ADDENDUM NO. 2

Date of Addendum: November 6, 2020

Owner: City of Thompson Falls

CITY OF THOMPSON FALLS, MONTANA WASTEWATER SYSTEM IMPROVEMENTS CONSTRUCTION PLANS

CITY OF THOMPSON FALLS, MONTANA
WASTEWATER SYSTEM IMPROVEMENTS
 LAGOON CELL 2B EFFLUENT LINE & MULTI-LEVEL TAKEOFF

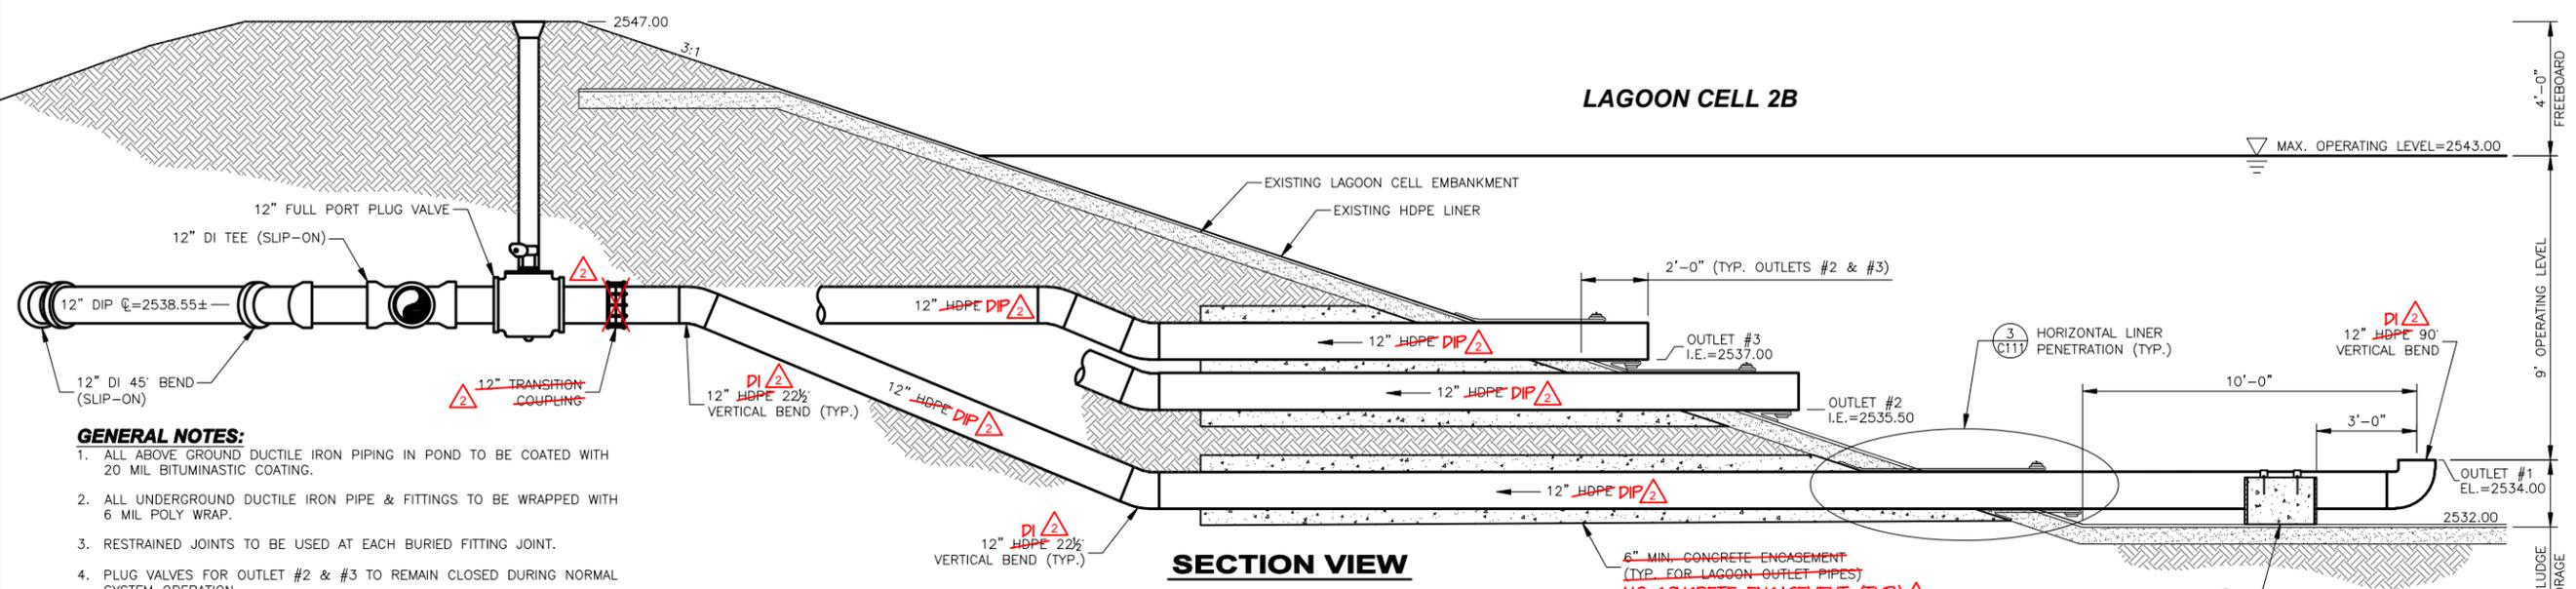
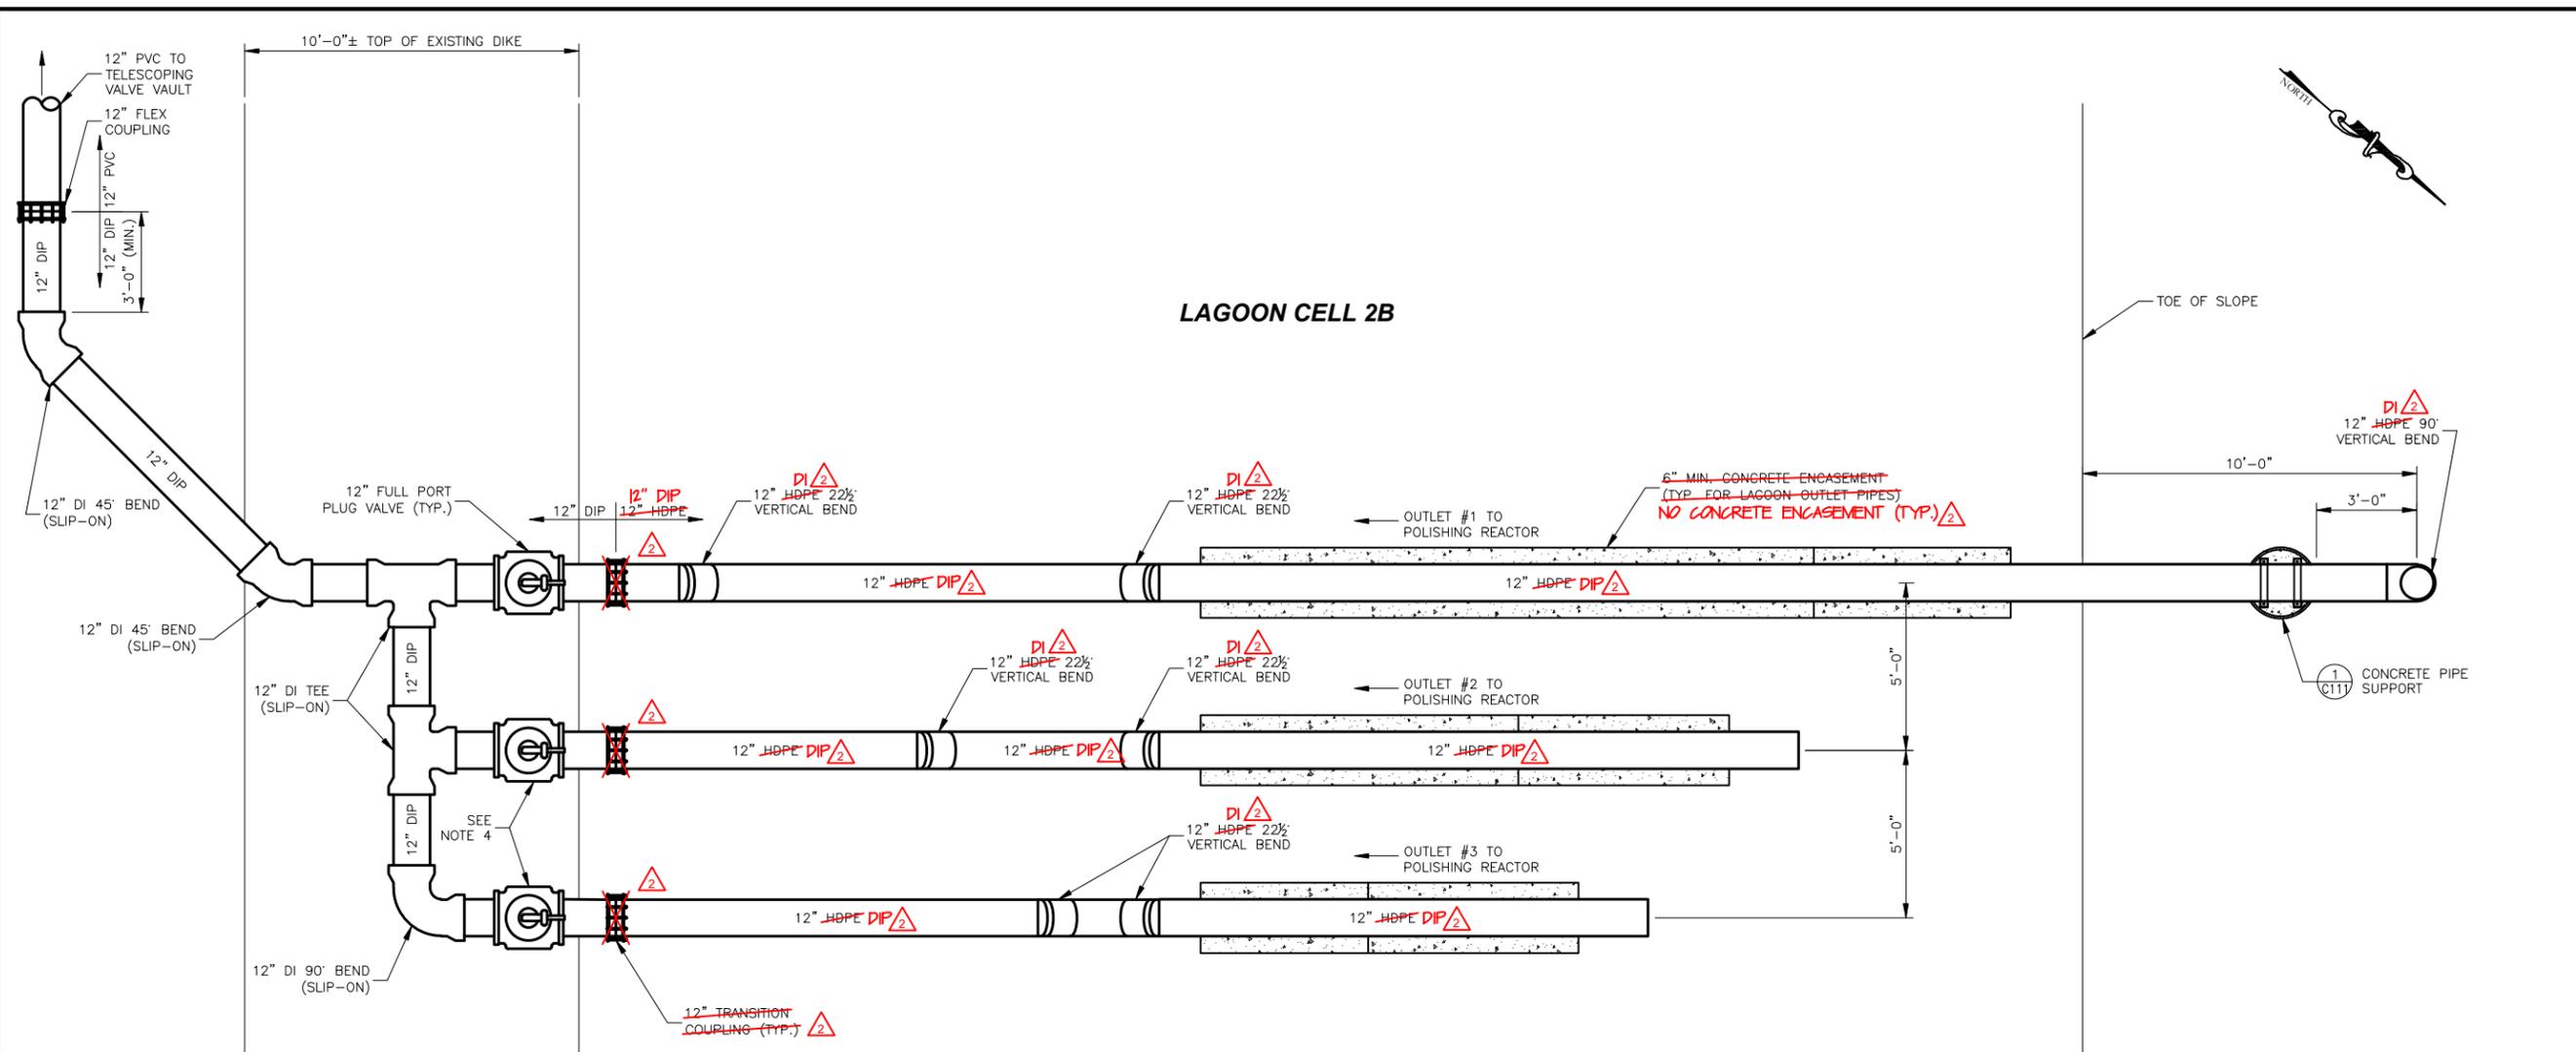
- h. Remove and replace Sheet C107 - Lagoon Cell 2b Effluent Line & Multi-Level Takeoff
 - i. Lagoon Cell 2b Multi-level takeoff piping to be DIP and remove concrete encasement as noted on replacement sheet C107.

2 LIGHT POLE BASE
 C115 NOT TO SCALE

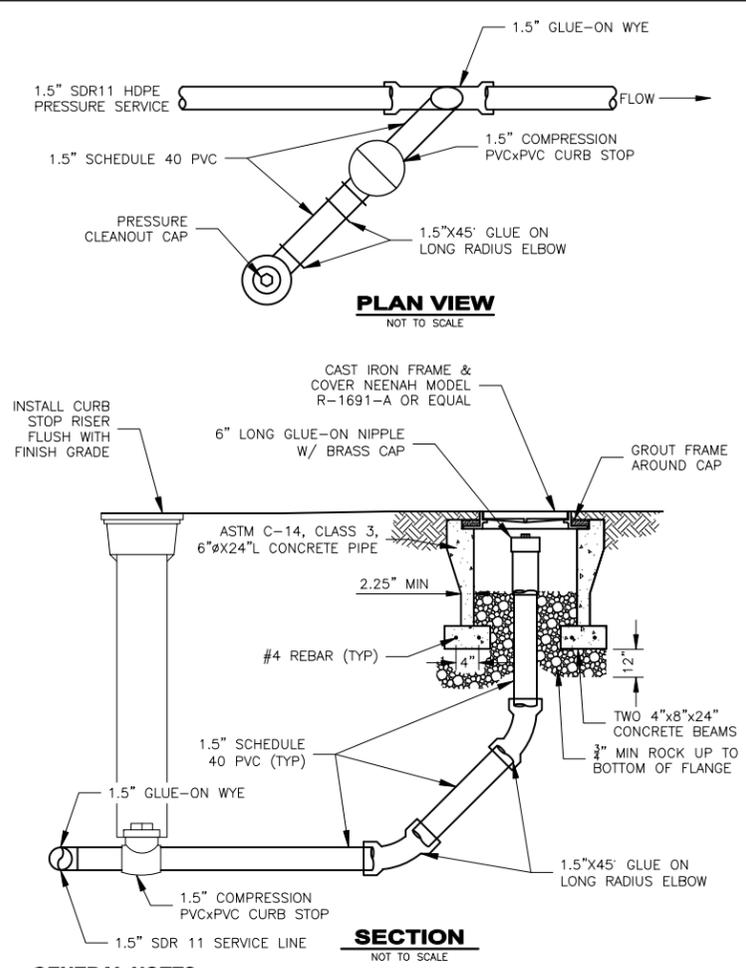
- i. Remove and replace Sheet C115 - Civil Standard Details
 - i. Detail 2 - Light Pole Base has been added.
 - j. Remove and replace Sheet P11 - Air Diffuser Assembly & Installation Detail

1 **DIFFUSER ASSEMBLY DETAILS**
P11 NOT TO SCALE

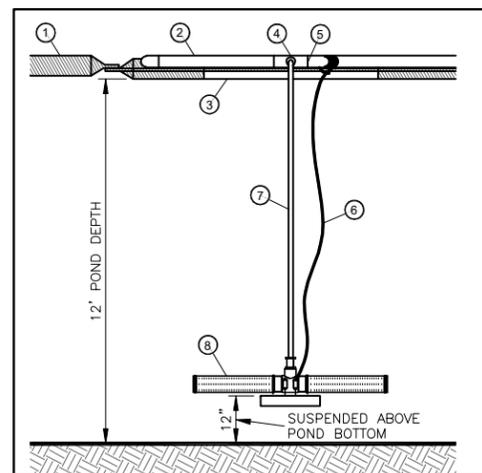
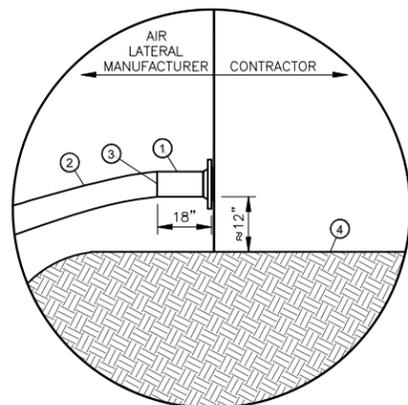
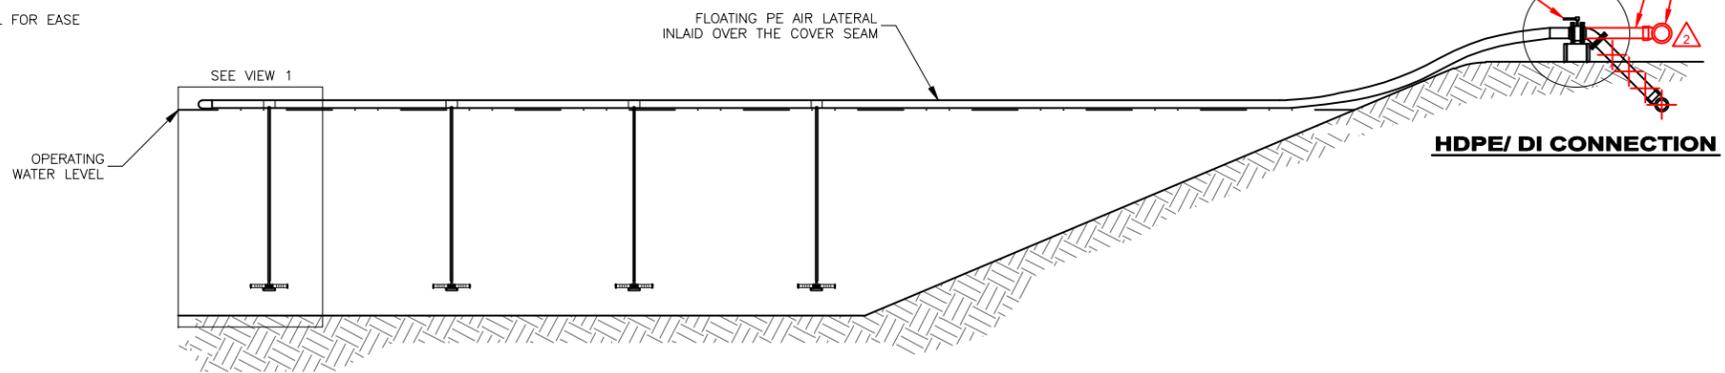
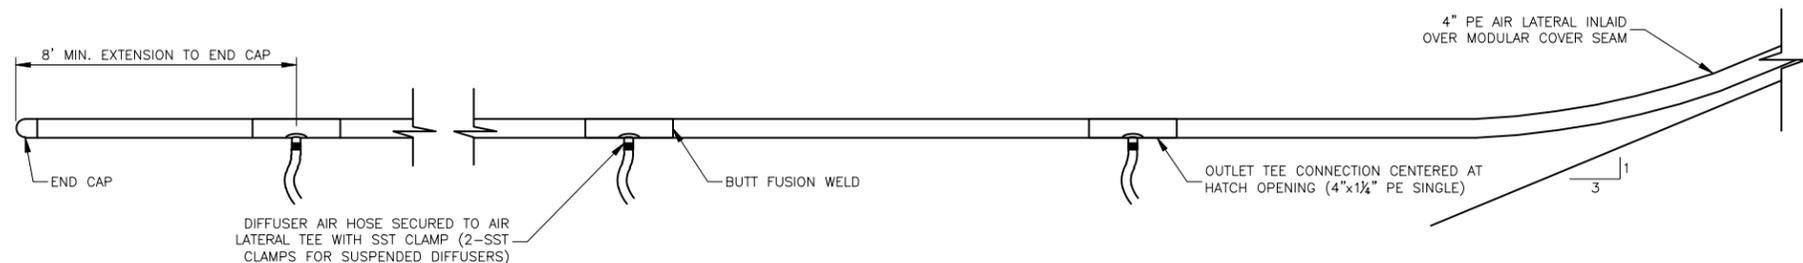
- i. Clarification for Diffuser Installation lateral connection has been added to detail.
